**MANDATORY  
SERVICE BULLETIN**

Service Bulletin No. 539A  
(Supersedes Service Bulletin No. 539 and Supplement No. 1)  
Engineering Aspects are  
FAA Approved

SUBJECT: Reprint of Crane/Lear Romec Service Bulletins No. RG9080-73-001, No. RG9570-73-001, and No. RG17980-73-001.

FUEL PUMP-Replacement of valve housing and related seals.

Regulator Valve Assembly Before Modification

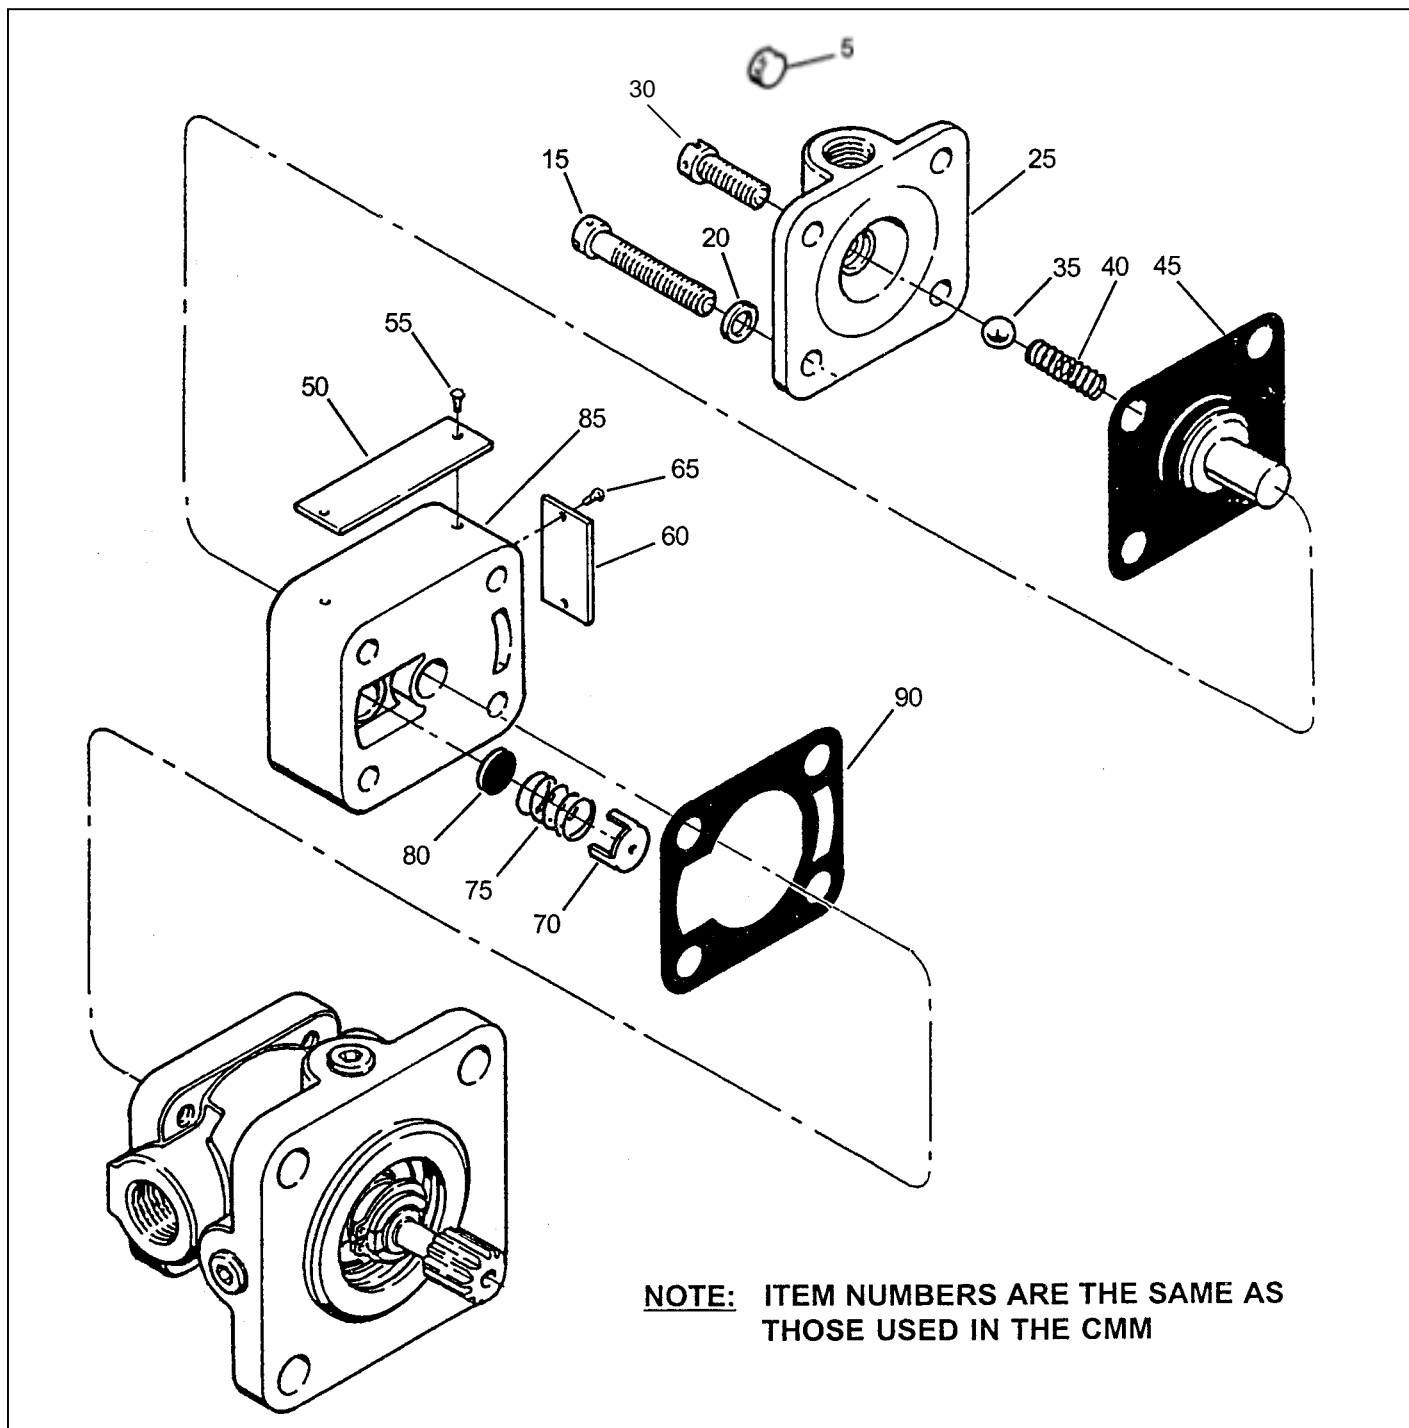
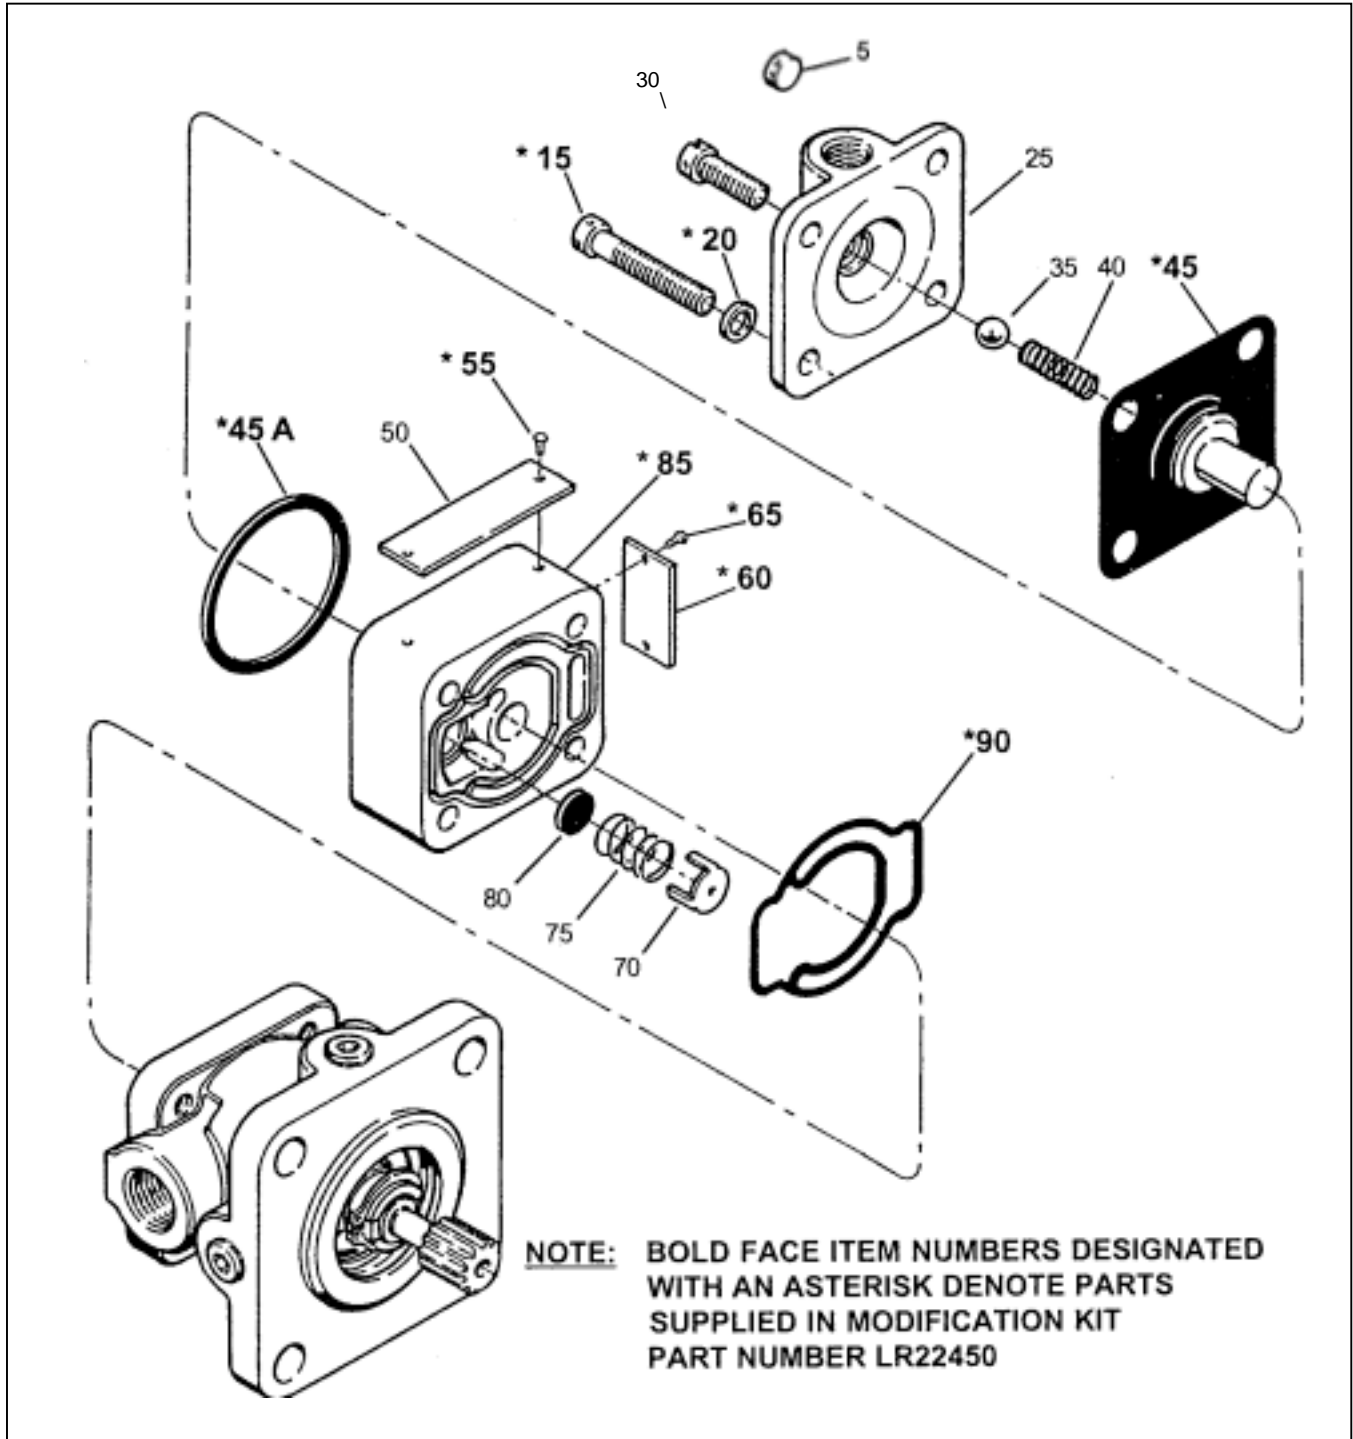
(2) Remove screws and washers (15 and 20, figure 1 ).

(a) Remove valve cover assembly (item 25, Figure 1) (if necessary rap cover with a plastic hammer to break the seal).

(c) Remove safety relief valve assembly (item 45, figure 1 ) from valve housing (item 85, figure 1 ).

(d) Tap off valve housing (item 85, Figure 1) with a plastic hammer. Remove and retain identification plate (item 50, figure 1 ). Peel off gasket (item 90, figure 1) (if necessary remove any clinging gasket material with a non-metalic scraper).

(e) Insert a suitable wire booking device into the hole located in the center of the bypass valve guide (item 70, figure 1 ) and withdraw the guide. Tilt valve housing and drop out the spring (item 75, figure 1 ) and bypass valve (item 80, figure 1 ).

- (4) Discard the following parts:
- (a) Four (4) each screws (item 15, figure 1 ).
  - (b) Four (4) each washers (item 20, figure 1 )
  - (c) One (1 ) each gasket (item 90, figure 1 ).
  - (d) One (1 ) each valve housing assembly (consisting of items 55, 60, 65 & 85 figure 1 ). Remove and retain identification plate for installation on new valve housing assembly (item 50, figure 1 ).
  - (d) One (1) each relief valve assembly (item 45, figure 1)

- (1) Bypass Valve. Install bypass valve (item 80, figure 2), bypass valve spring (item 75, figure 2) and bypass valve guide (item 70, figure 2) in valve housing (item 85, Figure 2). Bend prongs of bypass valve guide (item 70, figure 2) so that they fit snugly in valve port.
- (2) Lubricate the seal (item 90, figure 2) with petrolatum (petroleum jelly) and install it in the groove cut in the surface of the valve housing (item 85, figure 2) that mates with the pump housing.

- (3) Lubricate preformed packing (o-ring) (item 45A, figure 2) with petrolatum (petroleum jelly) and install it in the groove cut into the top of the valve housing assembly (item 85, figure 2).
- (4) Complete assembly according to the applicable component maintenance manual and secure the valve housing (item 25, figure 2) using screws (item 15, figure 2) and washers (item 20, figure 2). Tighten screws evenly and progressively in a crisscross pattern to 23-25 inch-pounds torque in the sequence shown in figure 3.

Torquing Sequence - RG17980 Series

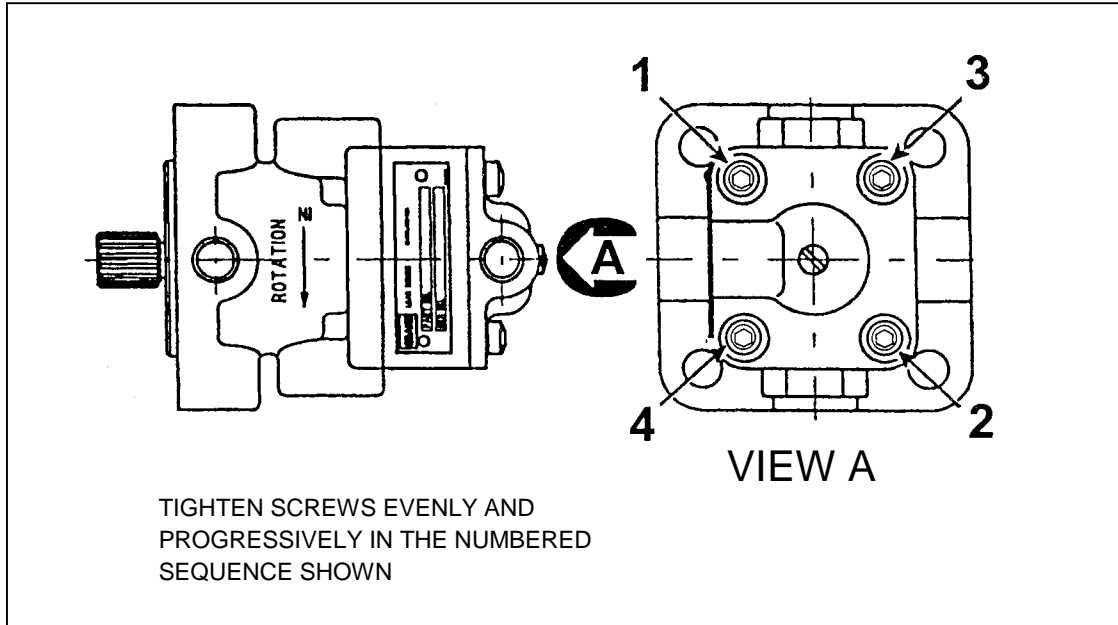
**CAUTION: SEAT THE COVER BY DRAWING DOWN THE SCREWS IN GRADUAL INCREMENTS, FOLLOWING A PROGRESSIVE CRISSCROSS PATTERN AS ILLUSTRATED IN FIGURE 3, UNTIL THE COVER IS FIRMLY SEATED. DRAW DOWN THE SCREWS EVENLY. DO NOT TIGHTEN SCREWS TO FINAL TORQUE DURING THE FIRST DRAW DOWN; UNEVEN TENSION CAN CAUSE DISTORTION OR OVERSTRESSING OF PARTS. COMPLETE THE PROCEDURE BY TIGHTENING EACH SCREW GRADUALLY TO THE SPECIFIED TORQUE VALUE. DO NOT EXCEED THE MAXIMUM TORQUE SPECIFIED.**
